Dewberry Response to USGS Review of NY Great Lakes- Chautauqua LiDAR Project

Produced for U.S. Geological Survey

Report Date: 1/12/2015

Figure 2 – USGS Screen Shot

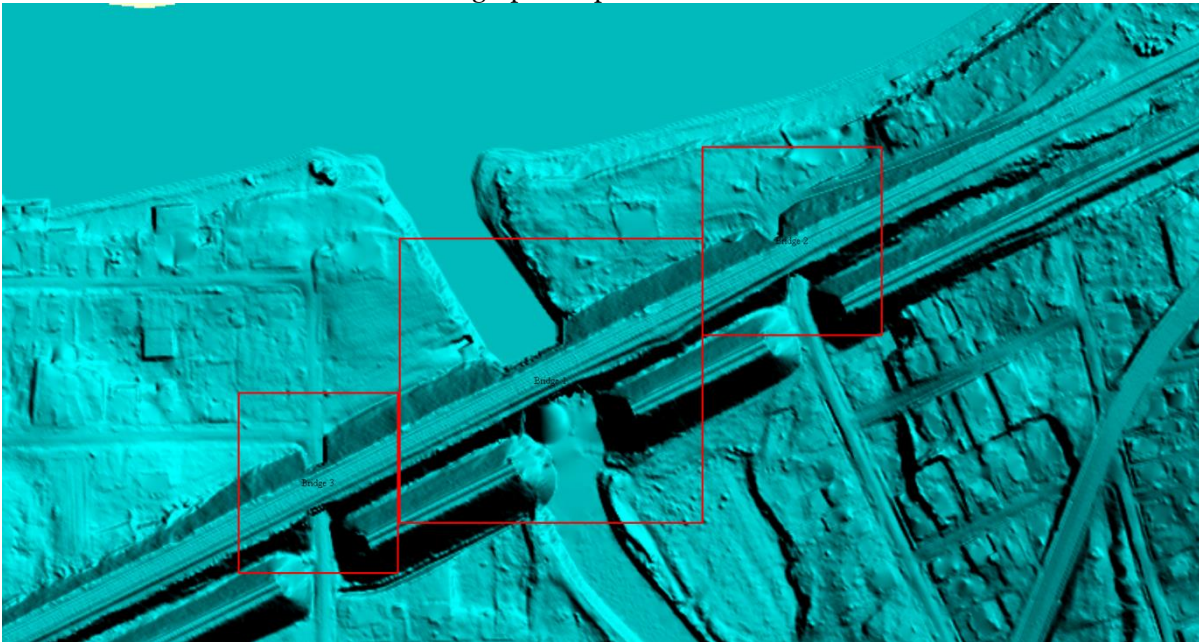
USGS identified these three bridges within one area as being left in the ground model. Dewberry found that these three structures are culverts. Photographic explanations can be found below.

Figure 4 - Tile 17TPH565180. Bing Imagery shows that there are cinders/ ground between the railroad tracks and along the sides of the track. These three features are culverts and remain modeled in the ground surface.

Figure 5 – USGS Image of DEM with bridge saddle.

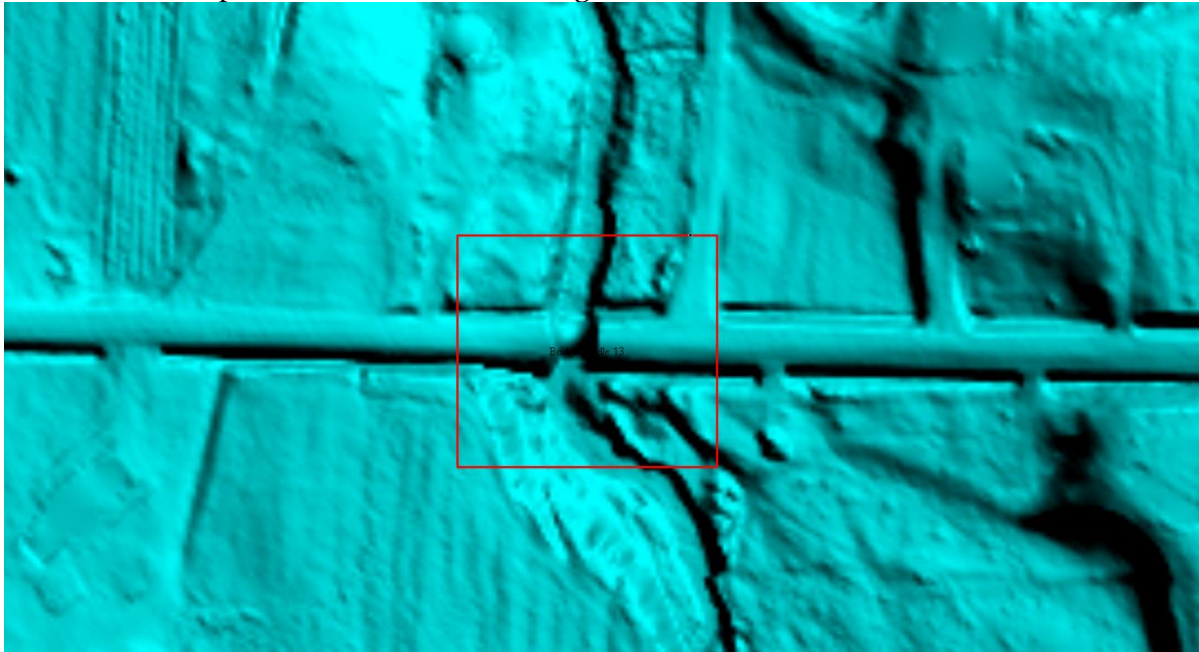
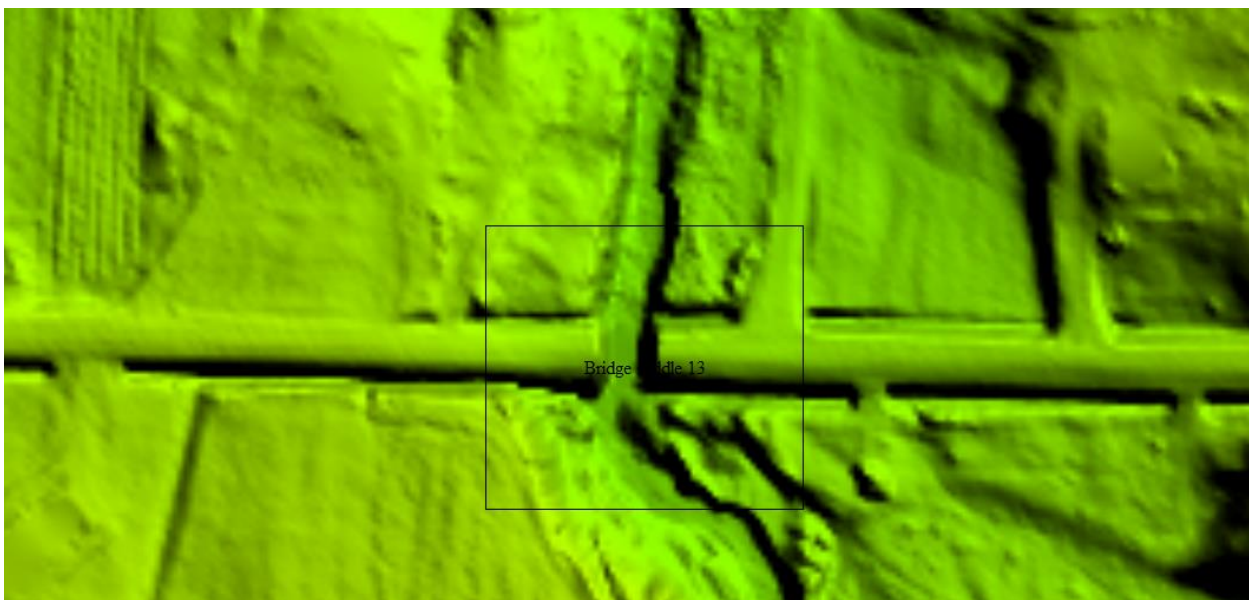
USGS marked 31 bridges that had saddles across the bridge expanse. Breaklines were added at these locations to help enforce the DEM and Contours in these areas. Delivered products and metadata were updated to reflect these changes.

Figure 6 – Tile 17TPH490120 DEM with bridge saddle fix.

Figure 7 – USGS Screen Shot

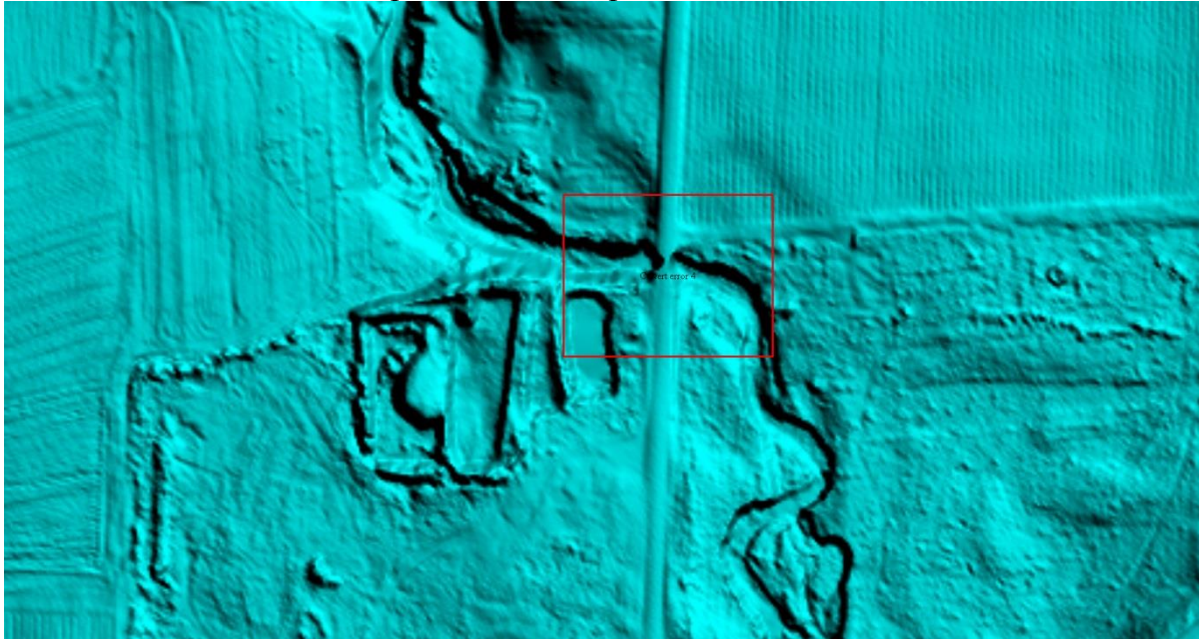
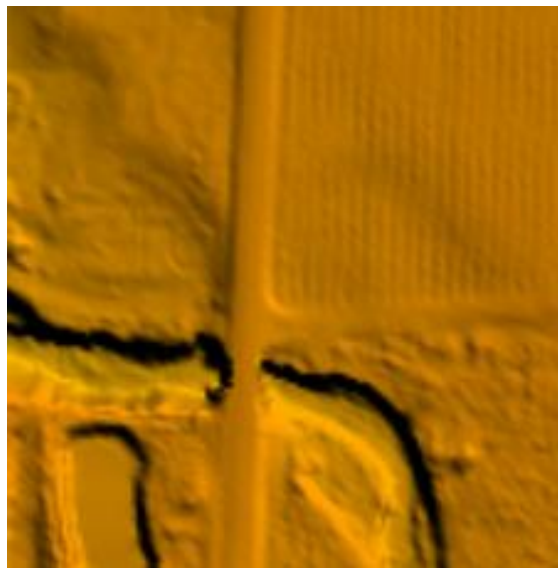
USGS found four (4) instances where box culverts had been removed from ground. Dewberry agrees that these should be returned to the ground surface model; the LAS has been re-classified and the DEMs and contours updated. An example can be found below

Figure 8 – DEM Tile 17TPG310000- Culvert points have been returned to ground.

Figure 9 –USGS Screen Shot

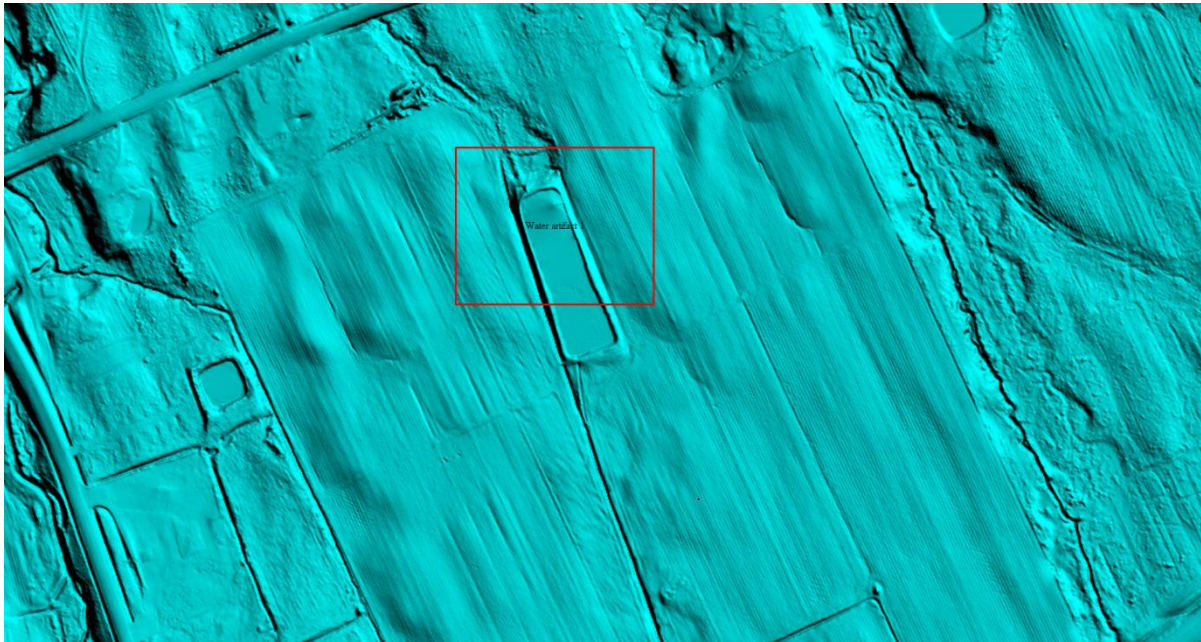
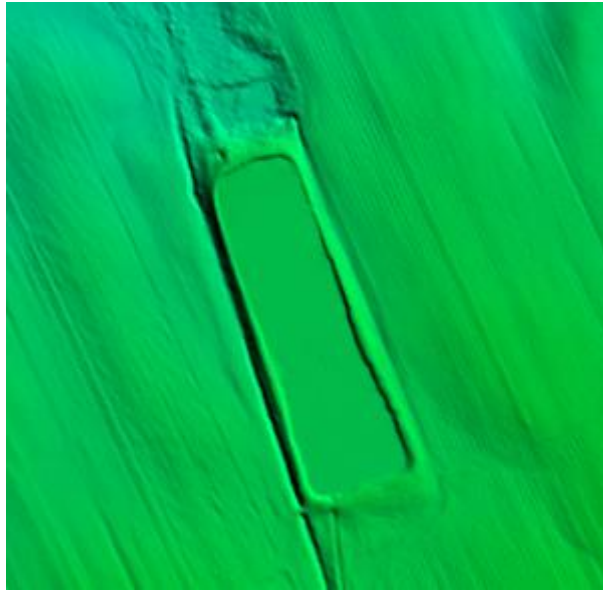
USGS identified one (1) pond that was below the 2 acre collection criteria that had a sizeable artifact and one (1) pond over 2 acres that had an elevation discrepancy between tiles. Dewberry has corrected these artifacts. Examples are shown below.

Figure 10 - Tile 17TPG085895. The artifact has been removed from the LiDAR and DEM.

Figure 14 –Tile 17TPH550150. Breaklines have been added, the LiDAR hydro-classified and the DEM hydro flattened.

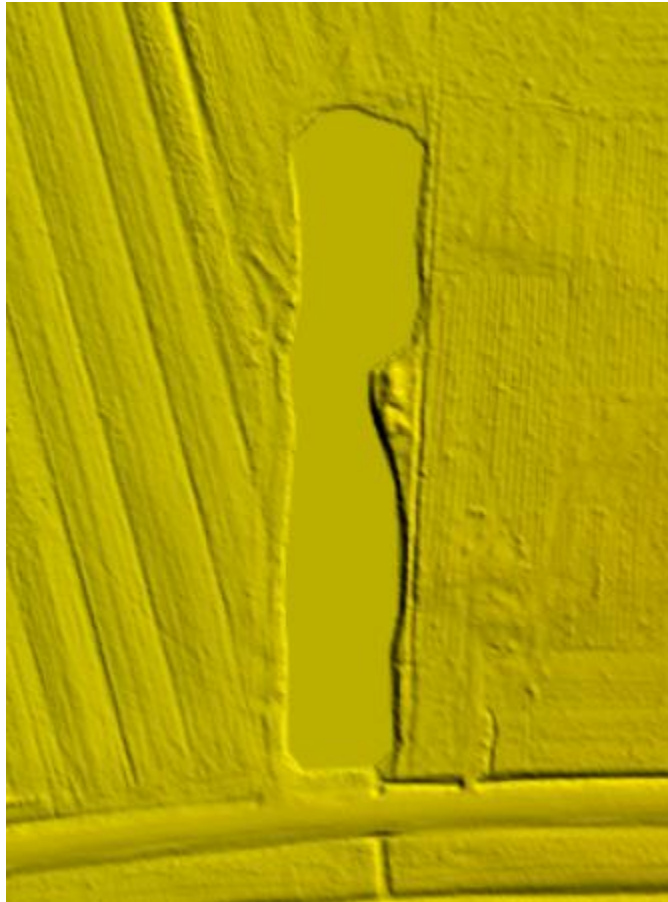
USGS identified one (1) pond greater than 2 acres in size that had not been collected with breaklines and flattened in the DEMs. This feature has been corrected in both the breaklines and DEMs. Examples are shown below.

Figure 15 - Tile 17TPH40090 and 17TPG40075. Screen shot of the DEM in area flagged by USGS as containing tinning.

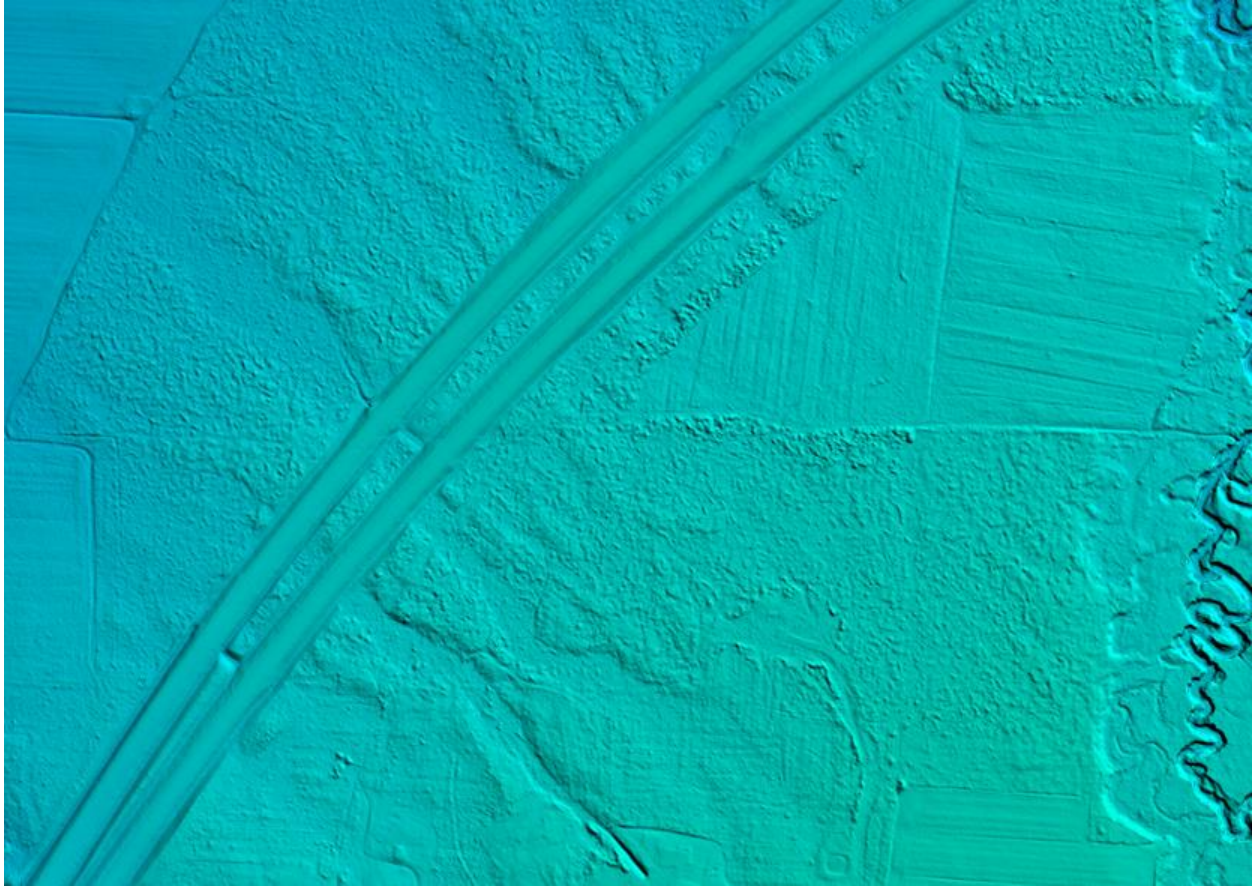
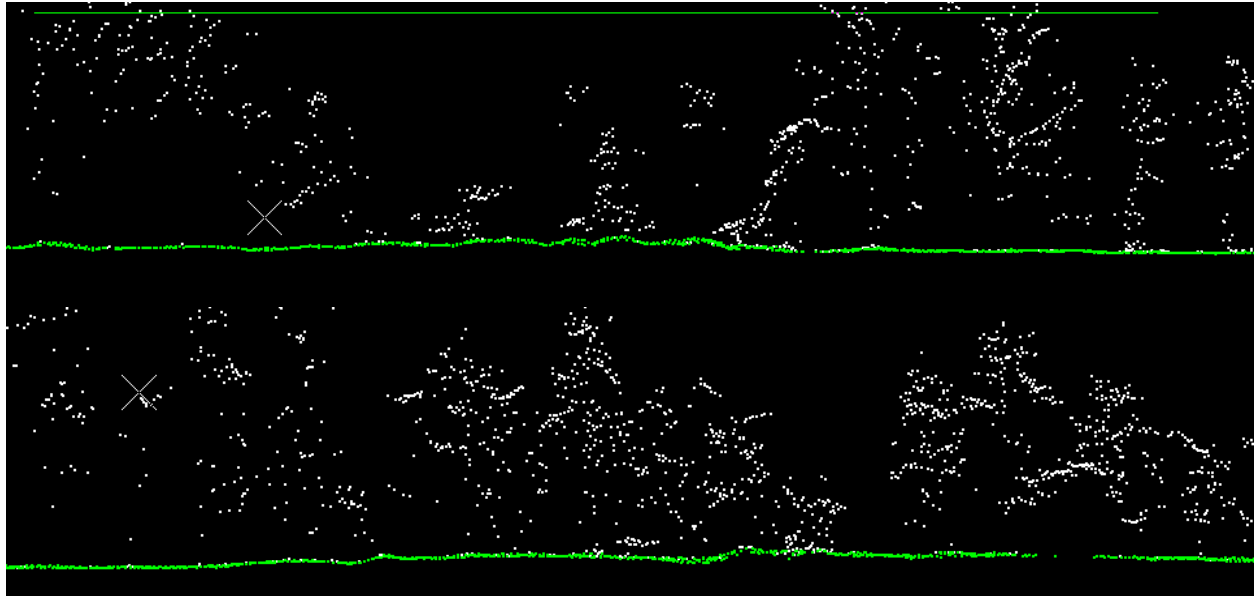
Tinning issues were not mentioned in the USGS review document but two areas were flagged in the Error Shapefile. The areas flagged with tinning occur in vegetated areas. As the profile examples below indicate, there are no additional points that can be classified to ground and all vegetation is classified to default, class 1.

Figure 16 - Tiles 17TPH40090 and 17TPG40075; Unclassified – White, Ground- Green. The top screenshot is an example from the LiDAR tile 17TPH40090 and the bottom screenshot is an example from the LiDAR tile 17TPG40075. There are no additional points available to re-classify to the ground class and all vegetation is appropriately classified to class 1.
